PRODUCT DISCONTINUATION

PD-DC-MUG7-13

Business Unit	Product Line Code	Type of Change	Action	Date of issue
DC	AAA	Mechanical	Notify Distributors and Field	9/10/2013

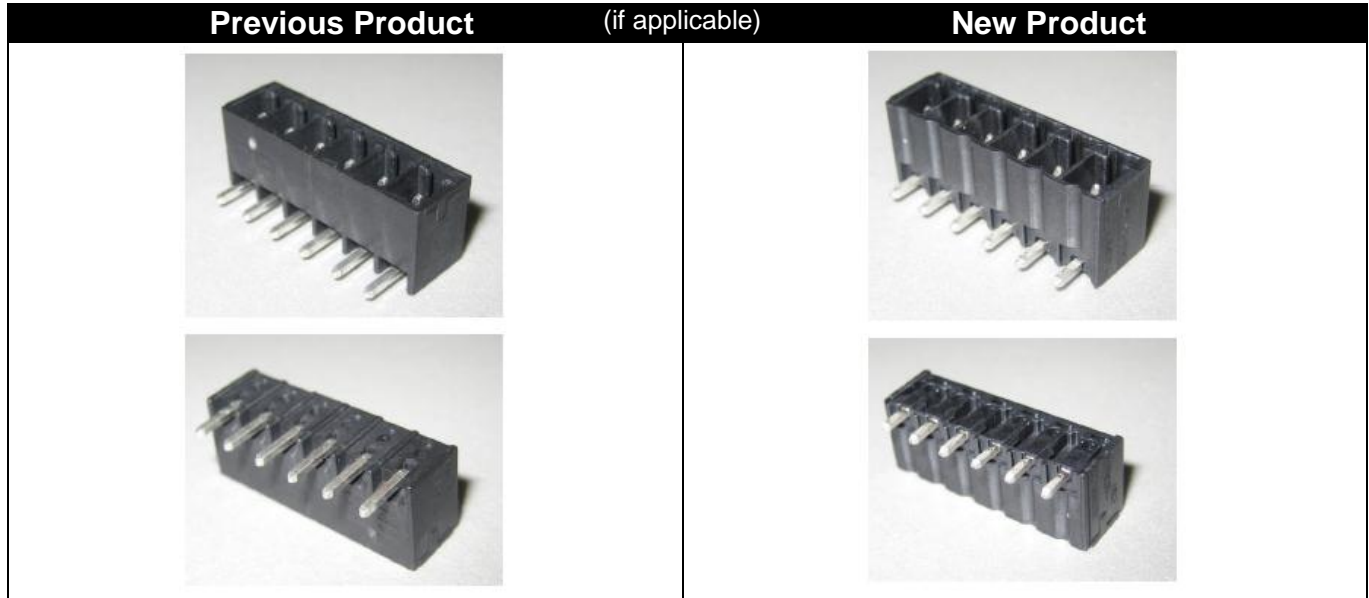
The parts of this product family have been optimized regarding their reflow process capability. The essential optimizations are as follows:

- The pin length from the housing's lower edge is reduced from 3.4 mm to 2.6 mm.
- The housing is made of LCP (Liquid Crystal Polymer).
- The qualification of the THR-products is in accordance to JEDEC J-STD 020D with a Moisture Sensitivity Level 1.
- There is no dry bag packaging necessary for MSL 1 products

The outer housing shape as well as the outer dimensions will not be changed. Only in the area where the pins are fixed in the housing will be affected. The free space areas around the pins for solder paste application as well as layout specifications are not affected by this optimization. There are no changes in the tape on reel packaging.
